- Reason for the change: Because of the WEEE directive 2012/19/EU, an indication of the recycling symbol (crossed-out wheeled bin with a solid bar (below)) is required.

■ Description of the Change: We will change the caution label as follows.

• MINAS A5 Family

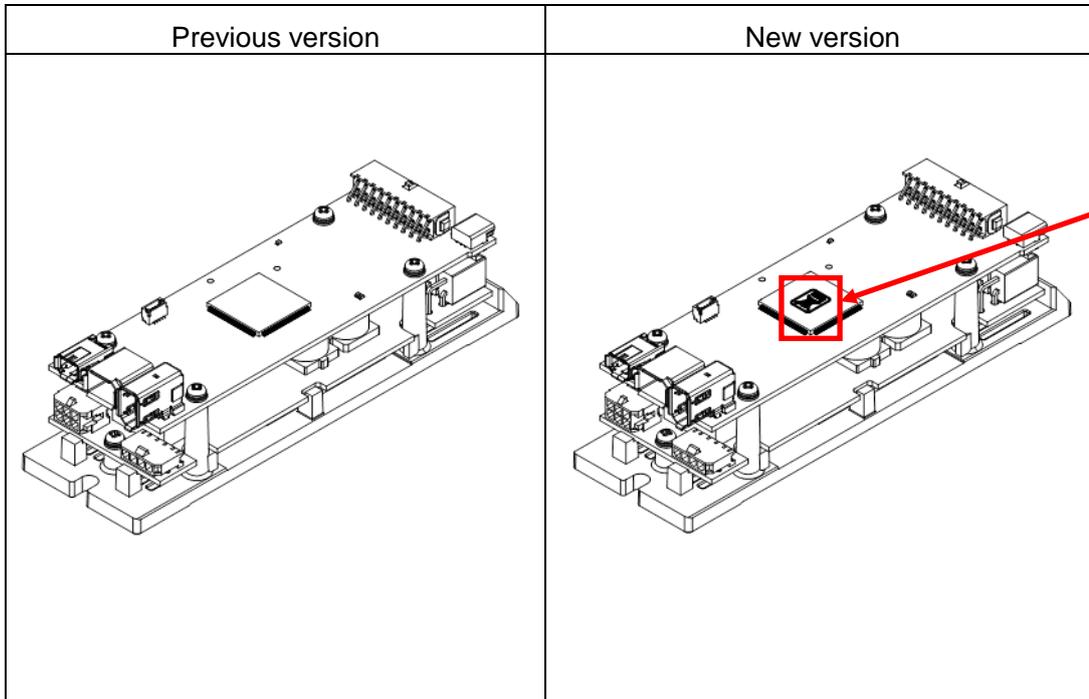
Recycling symbol label is added.

- MINAS-A4Family, E Series

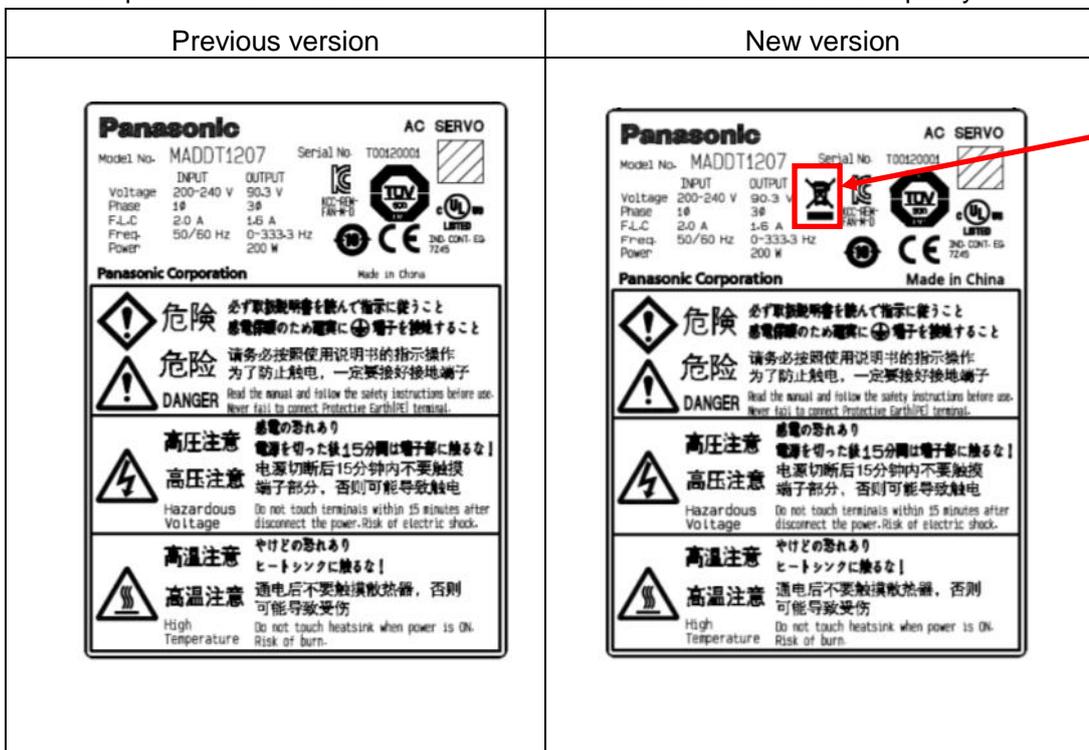
Recycling symbol label is added.

- MINAS A4, A5, A6 Family

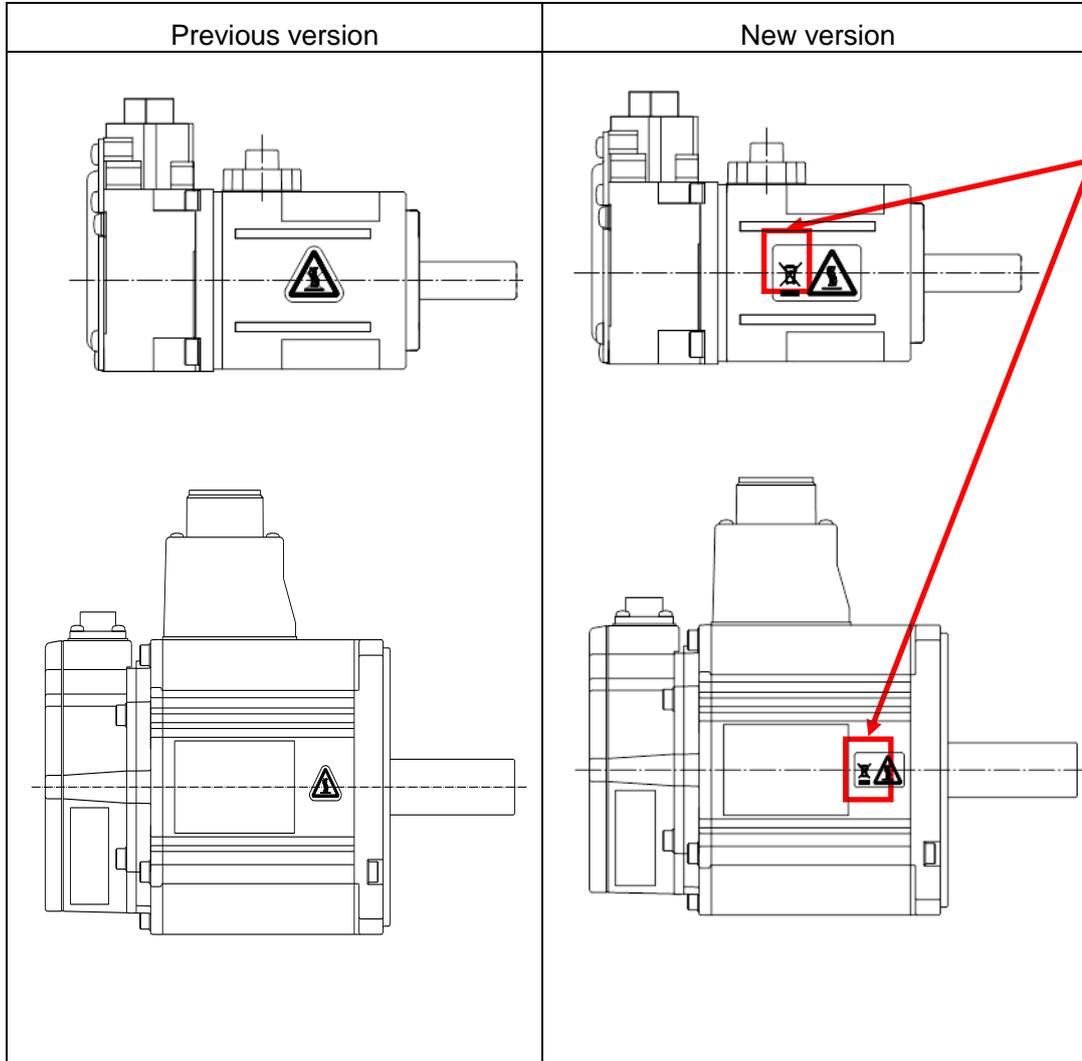
Recycling symbol is added to the high temperature caution mark.

- MINAS A6 MHMF Series Flange size 40 mm sq.
Example: MINAS A6 MHMF Series Flange size 40 mm sq.

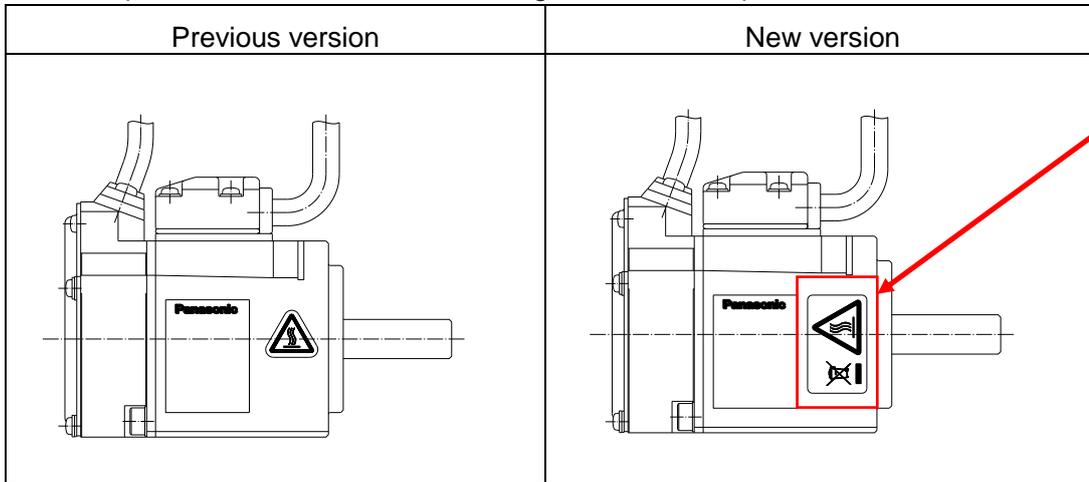
Recycling symbol is added to the high temperature caution mark, and the direction of the high temperature caution label is changed.

- MINAS A5M Series Flange size 25 mm sq.
Example: MINAS A5M Series Flange size 25 mm sq.

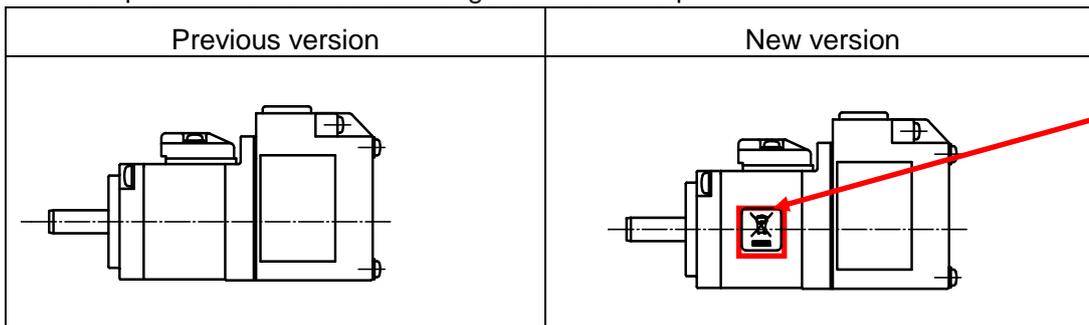
Recycling symbol is newly added.

Example: Junction cable for motor (MFMCA0030EED)

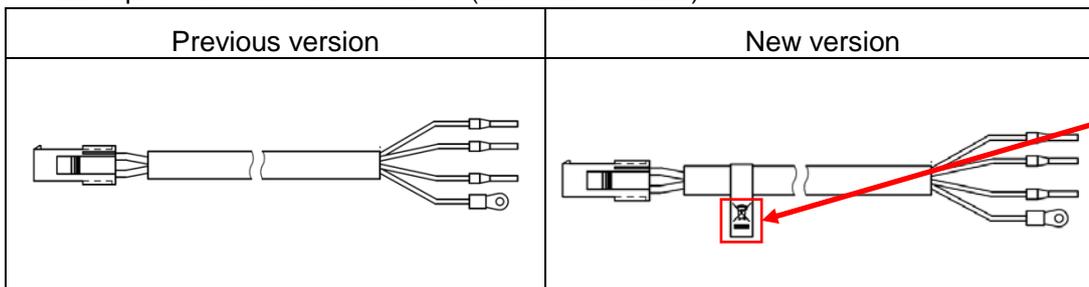
Recycling symbol is newly added.

* For a connector type optional cable of A5 and A6 series (flange size 80 mm or smaller), the recycling symbol is added to the existing ID label.
